Figure 2: Measurement of the Axial Play (A) of the Bearing

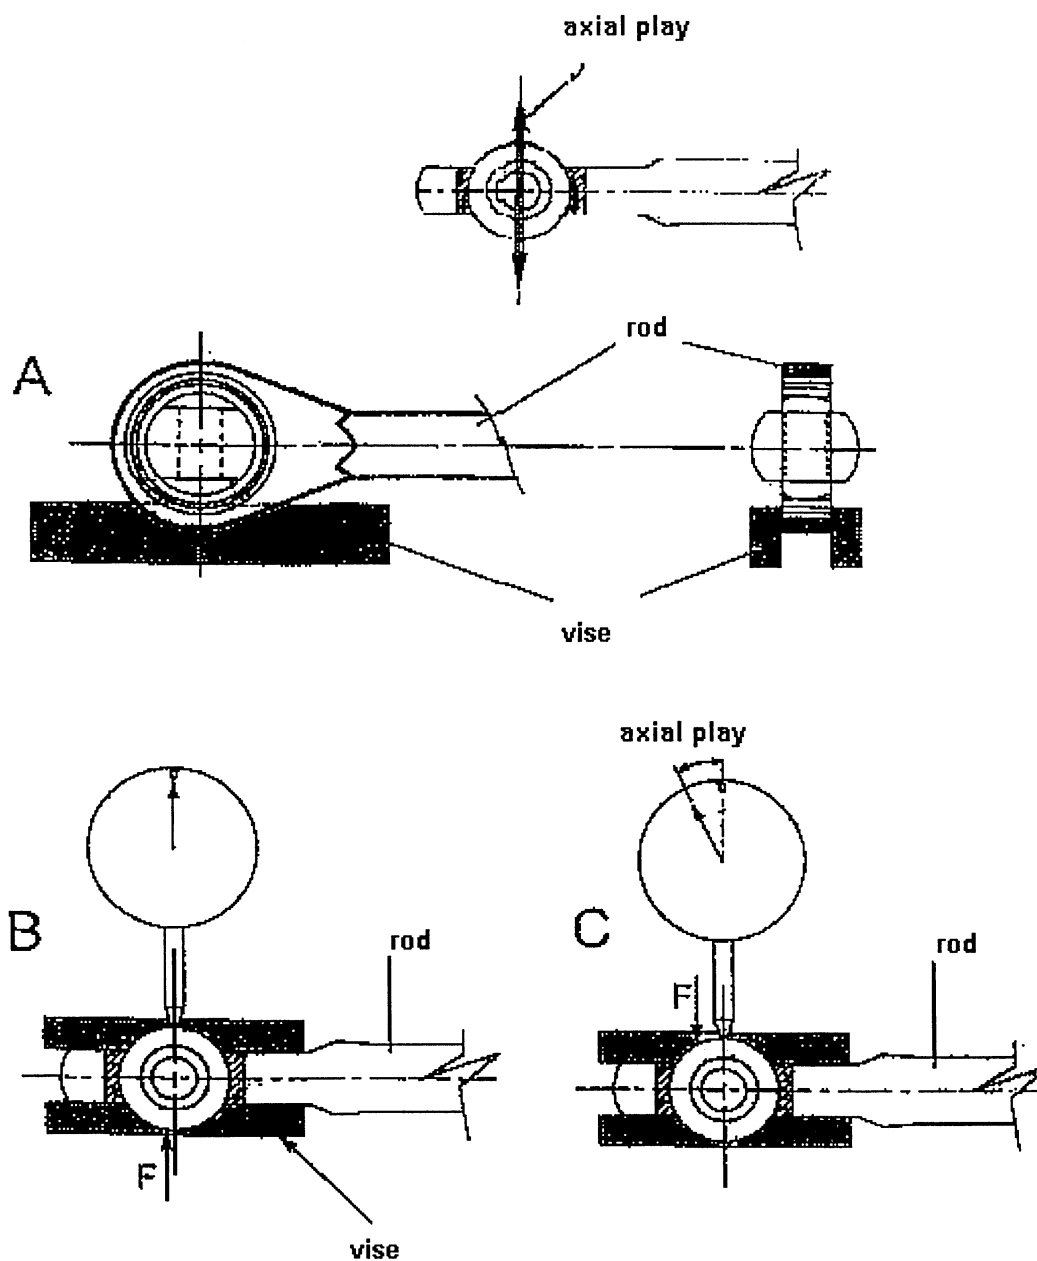
(b) If a pilot or mechanic detects play, a mechanic must remove the control rod from the helicopter, and using a dial indicator, measure the bearing wear according to the following and as shown in Figures 2 and 3 of this AD:

(1) If the Teflon cloth is coming out of its normal position within the bearing, totally or partially, or if there is discoloration or scoring on the bearing, the bearing is unairworthy.
